Subject: WHITE STAINS FROM OUTER DOOR MIRROR RUNNING DOWN DOOR PANEL	Bulletin No: 09-028/13
	Last Issued: 10/31/2013

2013-2014 CX-5 vehicles with VINs **between** JM3KE*****138997 ~ 398338 and produced from July 24, 2012 to October 1, 2013

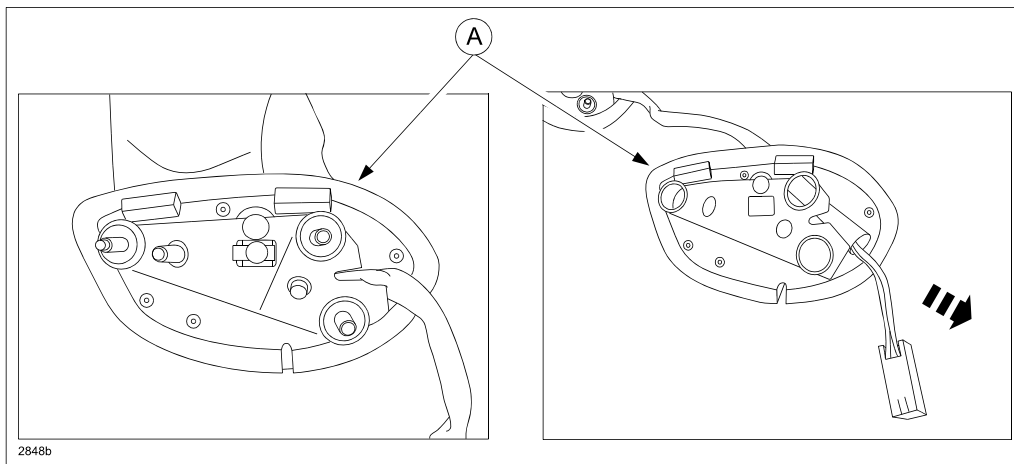
1. Verify the customer concern.
2. Remove the power door mirrors on both sides according to the instructions in Workshop Manual "POWER OUTER MIRROR REMOVAL/INSTALLATION".
3. Remove the gasket (A) from the mirror base.

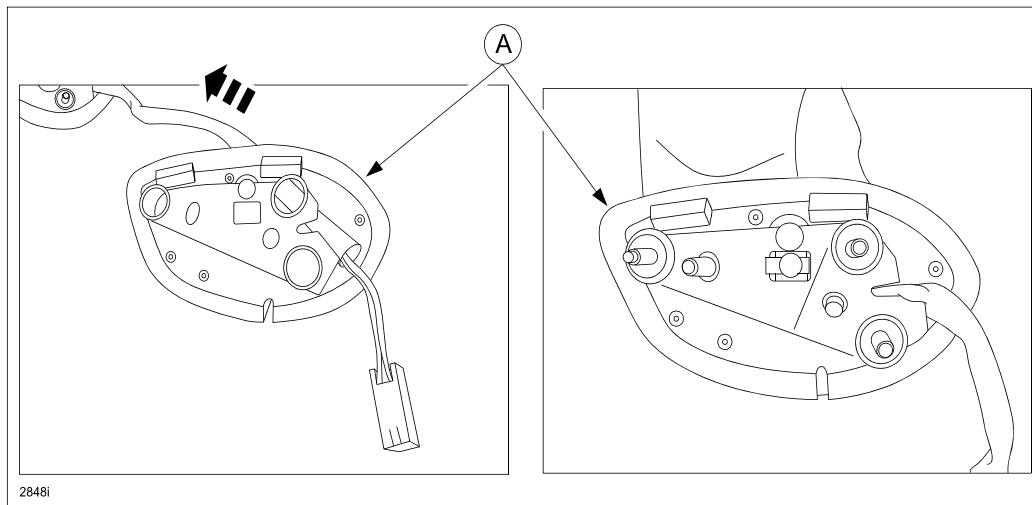
The door mirror base was originally designed to drain water to the outside of the door. The shape of the door mirror base gasket has been modified to now drain water to the inside of the door. Replacing the gasket should eliminate this concern.

10. Let the **ValuGard Rust Preventative** product air dry.
11. Remove the masking tape.
12. Install a modified gasket (A) onto the mirror base.
